August 19, 1999

NEL-99-0293

Joseph M. Farley Nuclear Plant
Revised Response to Request for Additional Information Related to Conversion to the
Improved Technical Specifications – Chapter 3.1 and
Response to Requests for Additional Information – Beyond Scope Issues - Chapters 3.5 and 3.8

FIGURE 3.5.5-1
SEAL INJECTION FLOW LIMITS

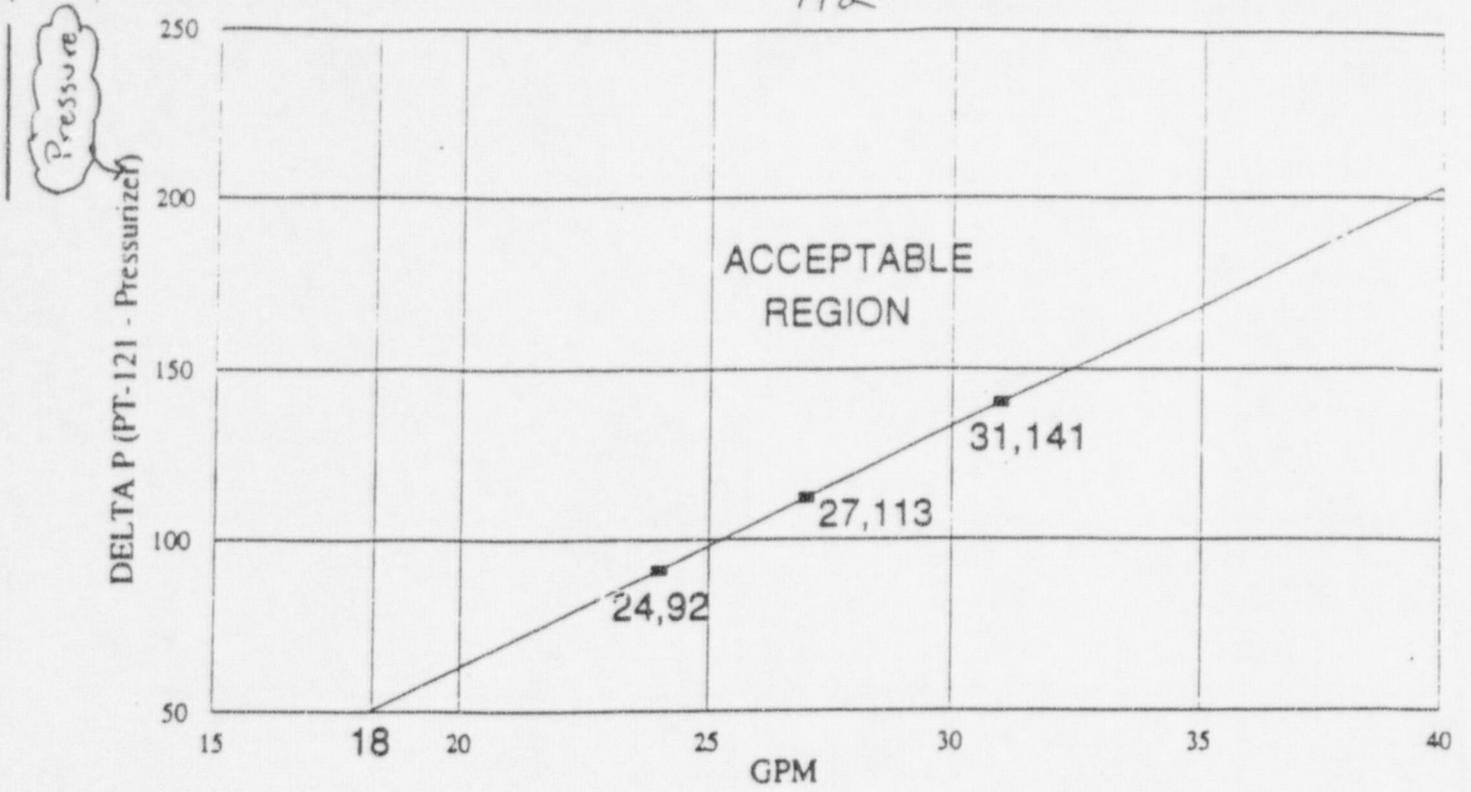
It is acceptable to use a graph for seal injection flow requirements for ITS LCO 3.5.5. However, the graph must be contained in the TS rather than the Bases.

SNC has moved the graph into the TS.

<u>JD NUMBER</u>	<u>JUSTIFICATION</u>
1	LCO 3.5.5 for Seal Water Injection Flow is revised to utilize a graph to indicate the limits for seal injection flow. These limits are better expressed graphically than by a single point on a curve. The appropriate seal injection flow can be determined based on the difference between the Pressurizer pressure and the charging discharge header pressure. The points on the graph are based on FNP-specific safety analysis assumptions which provide the relationship between seal injection flow, Pressurizer pressure, and charging discharge header pressure over a range of values for each of these parameters. The surveillance requirement will require the flow to be within ECCS safety analysis limits as expressed in the figure. Therefore, the figure must maintain those limits. Hence, the TS requirements will continue to maintain ECCS performance within the envelope of the safety analysis.

Page 153 (graph)
Moved into
LCO
